ADDENDUM NO. 1

**RESTROOMS & LAUNDRY RENOVATION
KEYW WEST HISTORIC SEAPORT
ITB #17-007**

ADDENDUM NO. 2

RESTROOMS & LAUNDRY RENOVATION KEYW WEST HISTORIC SEAPORT ITB #17-007

Three-Stall Shower Unit

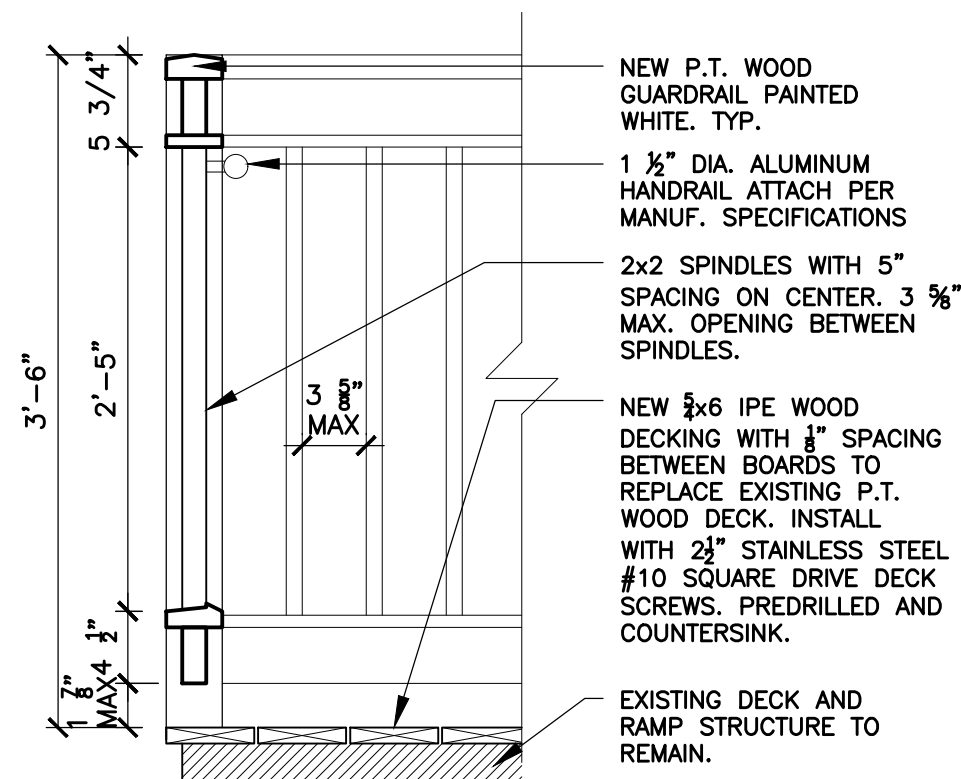
- 2.) Provide two (2), portable three stall shower/combo units by Royal Restrooms or Equal to maintain the function of the facility at both Building 'A' and Building 'B' for duration of project. One portable shower/combo unit to be placed behind each

FLOOR PLAN — BUILDING 'A'

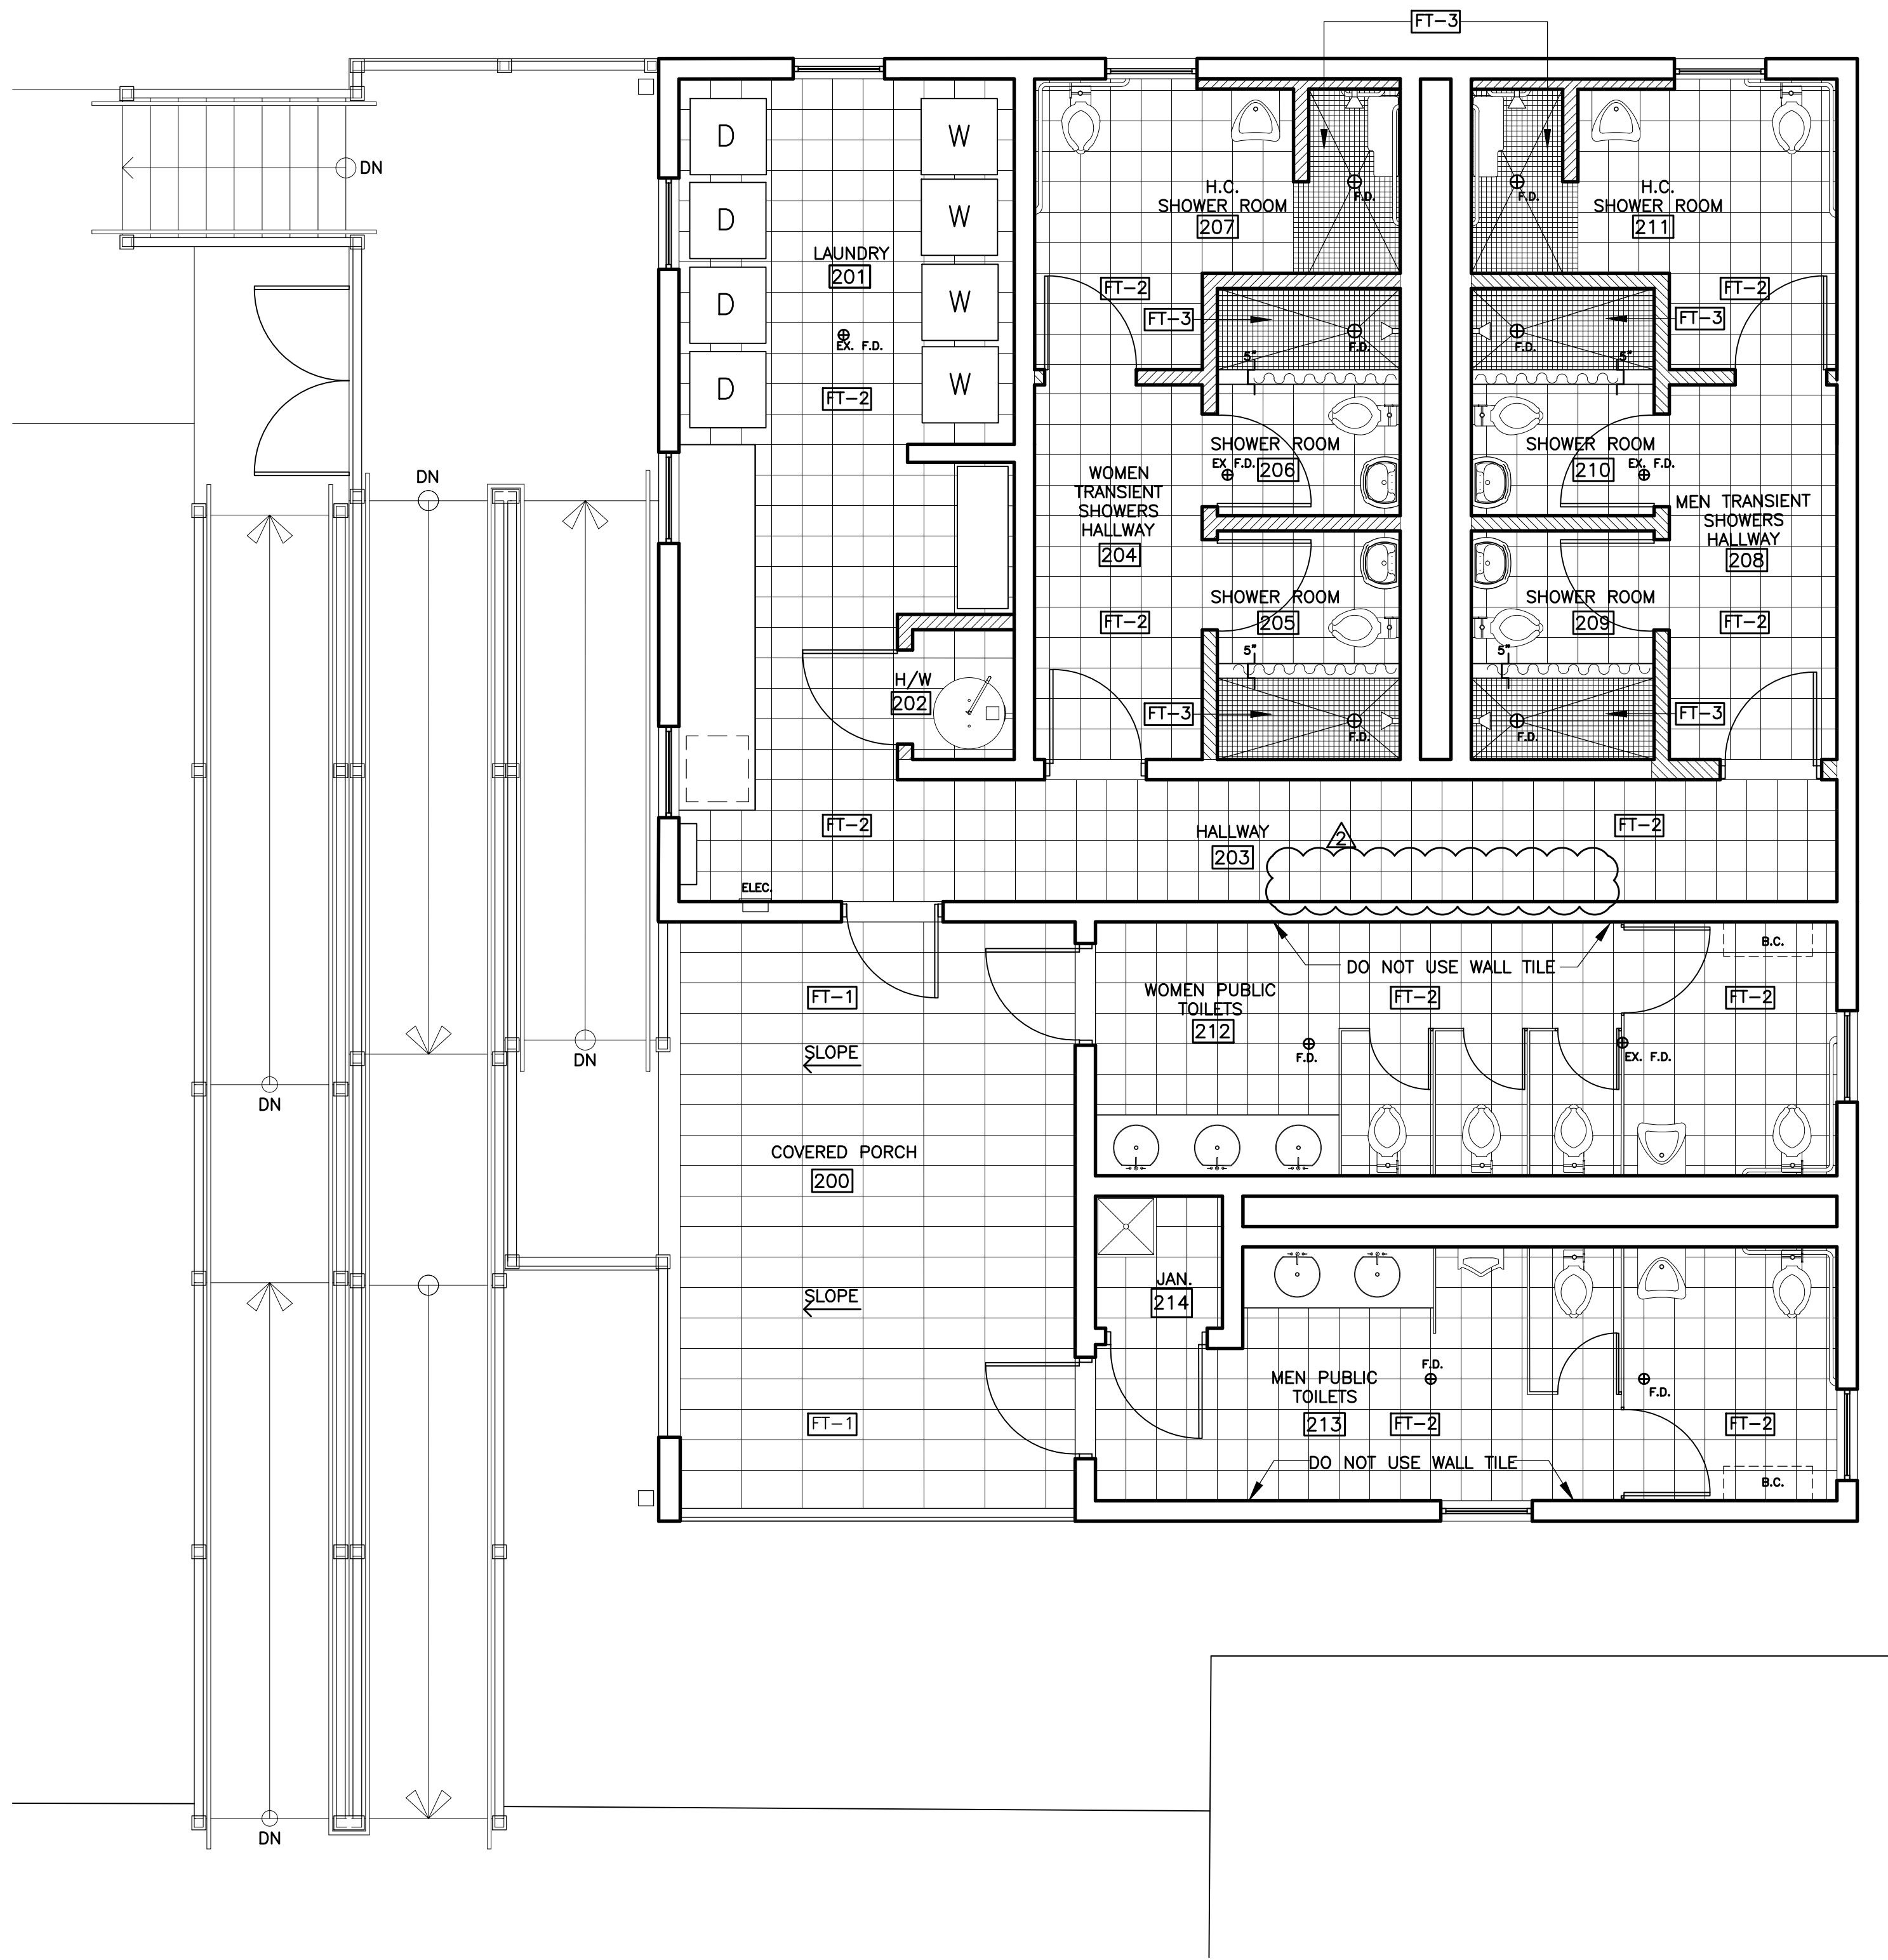
6. On Building 'A' Floor Plan sheet A-2.0, north wall room 213 floor plan shows clean and paint, however, on elevation 6 sheet A-4 it shows north wall to receive wall tile. Will north wall of room 213 be paint or tile?

North wall of room 213 is to receive tile finish per sheet A-4. Refer to revised A-2 for clarification.

1
A-5
TILE FLOOR PLAN — BUILDING 'A'
SCALE: 1/4"=1'-0"

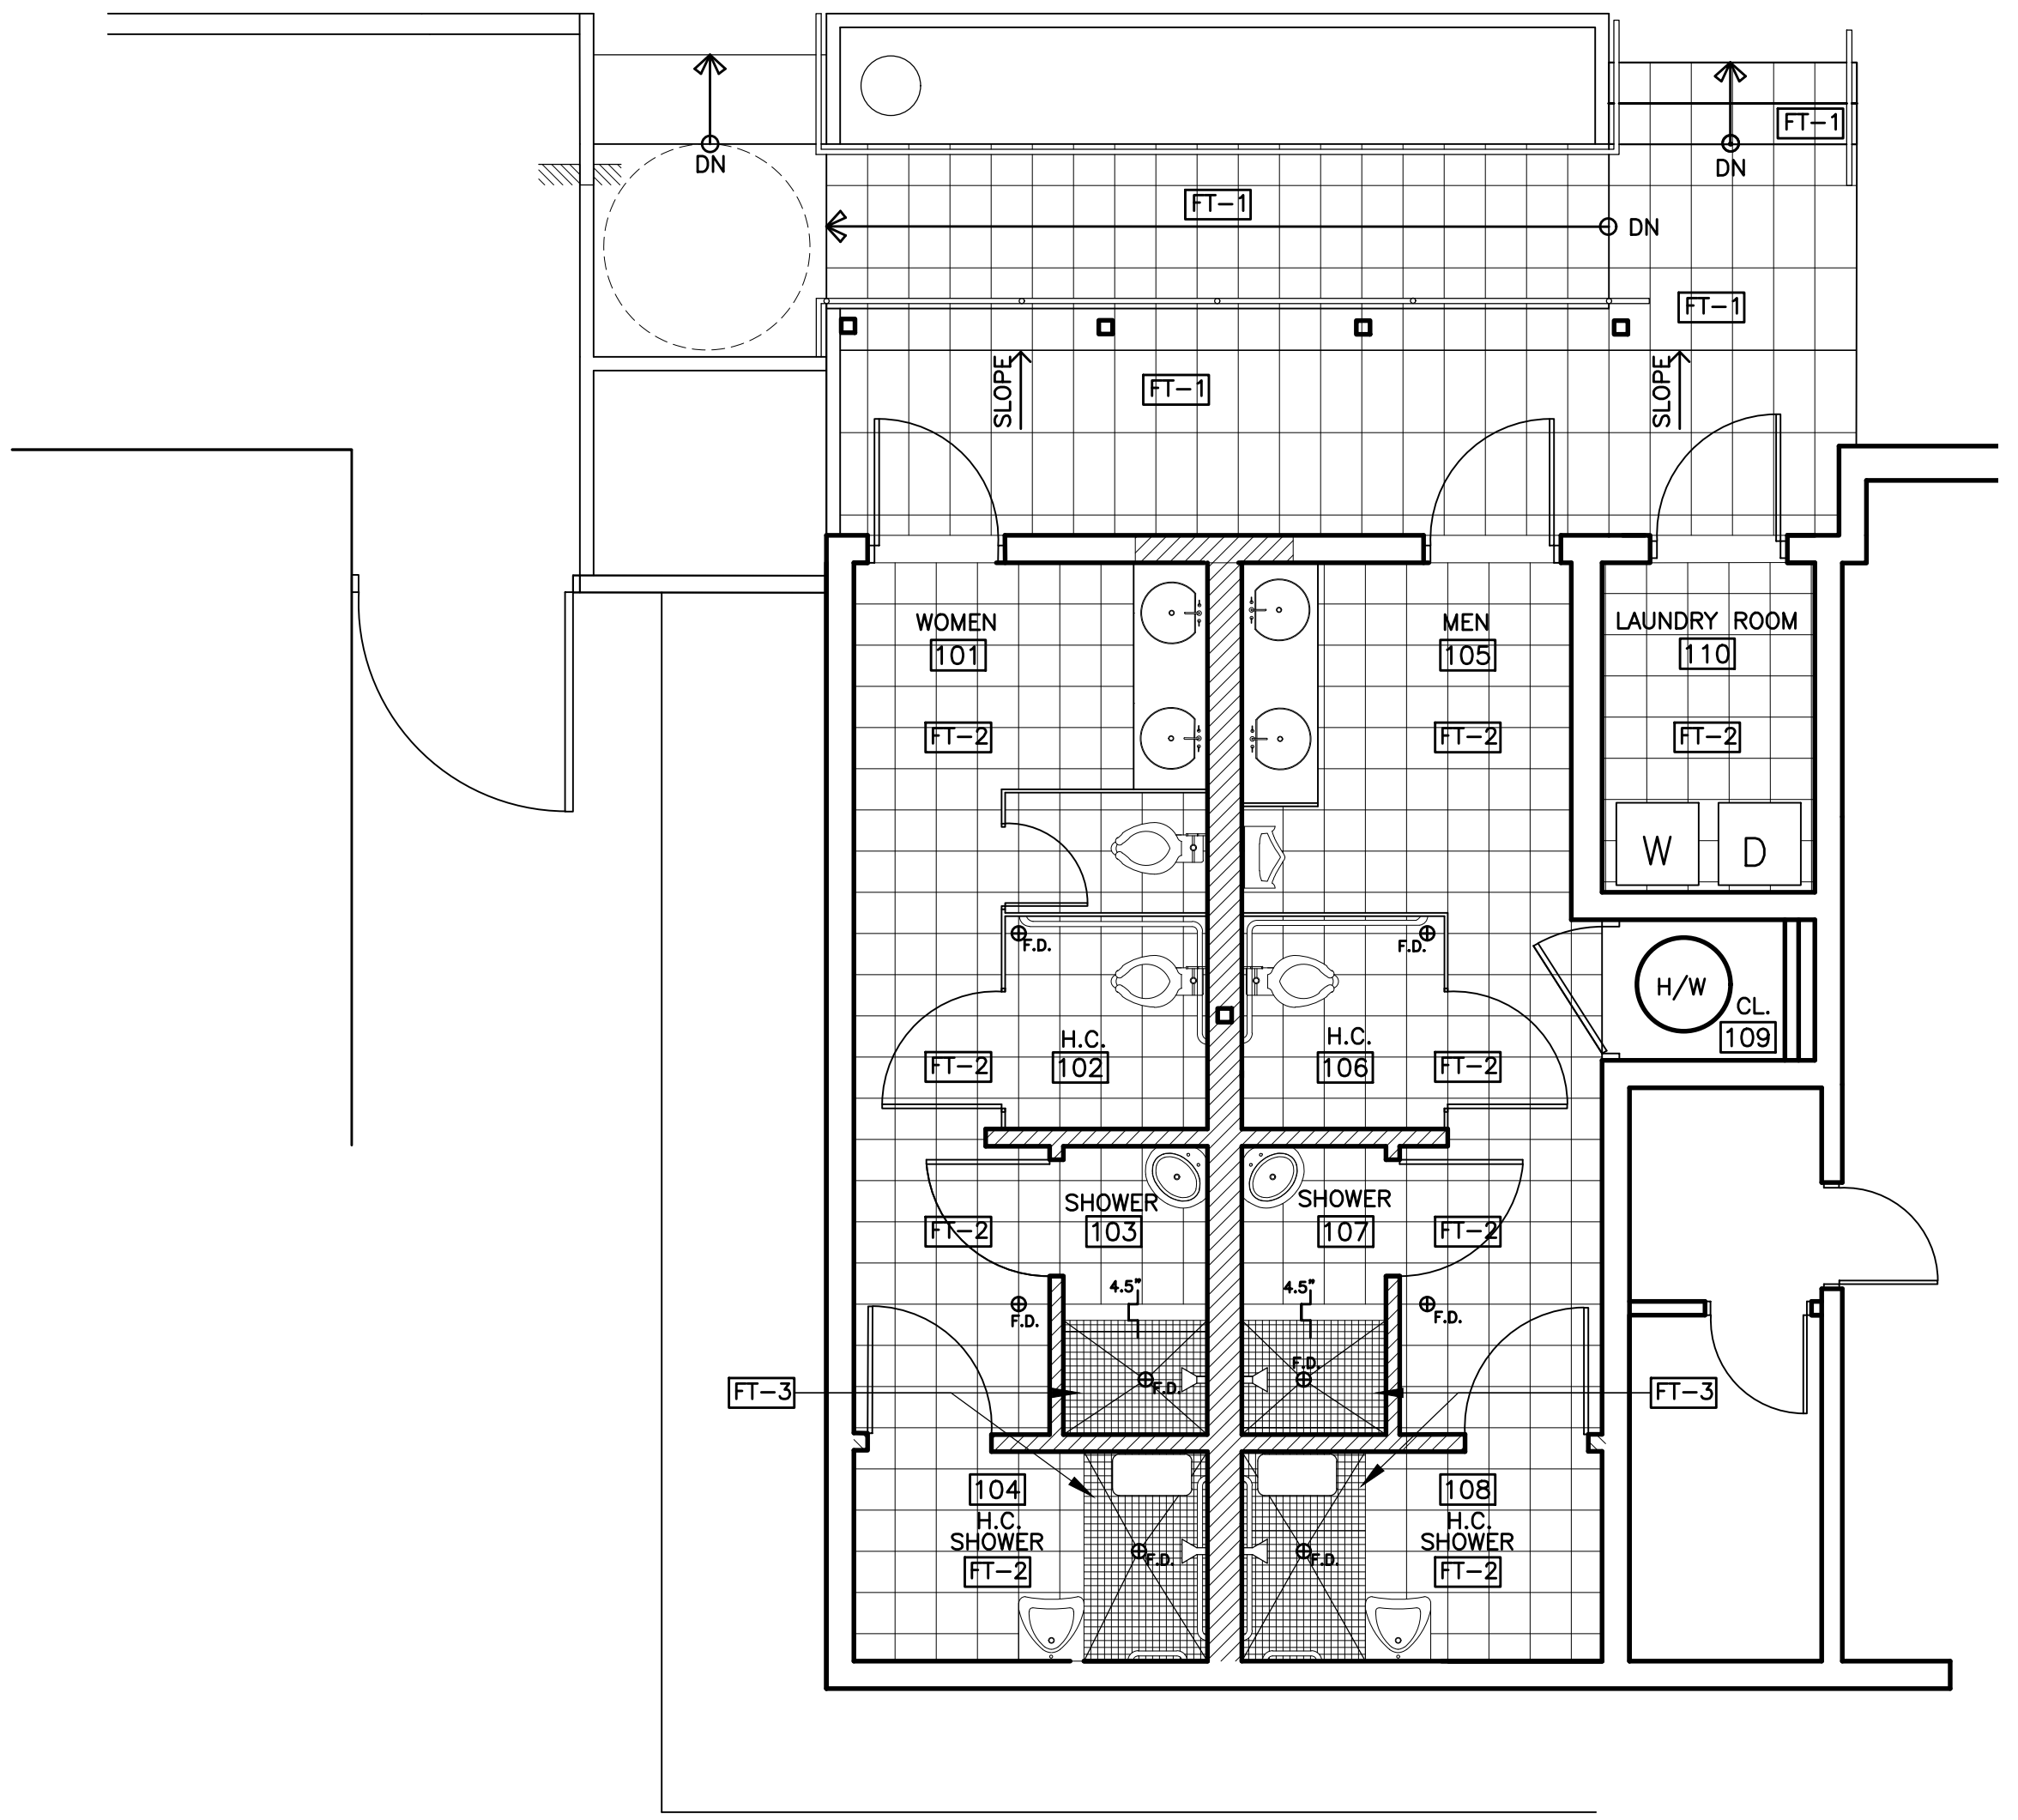
7. On Sheet A-5, there is a bid alternate for FT-1. There is not space for this alternate on the bid form.

10. Building 'A' on sheet A-5.0 shows room 203 hallway Do Not Use Wall Tile north and south walls. However, finish schedule shows room 203 hallway to receive ceramic wall tile. What finish will room 203 receive? Please see attachment for reference.

Room 203 will receive tile on the walls. See revised drawings.

FT-1 BID ALTERNATE: BRUSHED CONCRETE (COF \geq .80 WET/DRY)

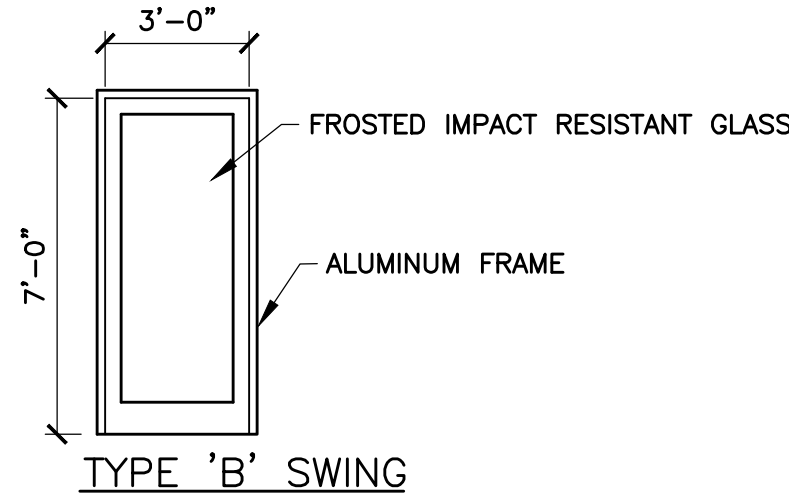
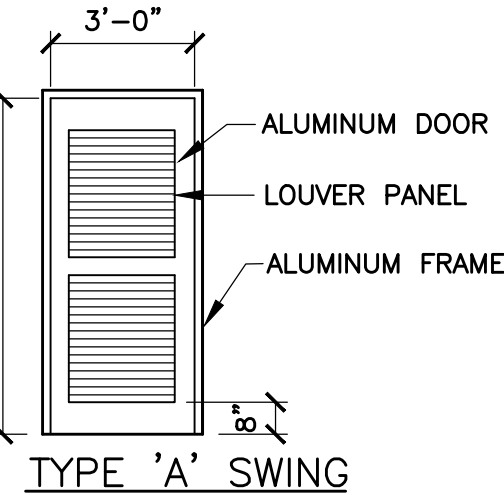
1. Building 'A' Door Schedule: Mark #01 thru 09 and 13 show galvanized metal in the door material and frame material column, but the elevation for type 'A' shows and aluminum door and frame. Are these hollow metal openings or aluminum openings?

Doors indicated in question are to be aluminum. See revised drawings.
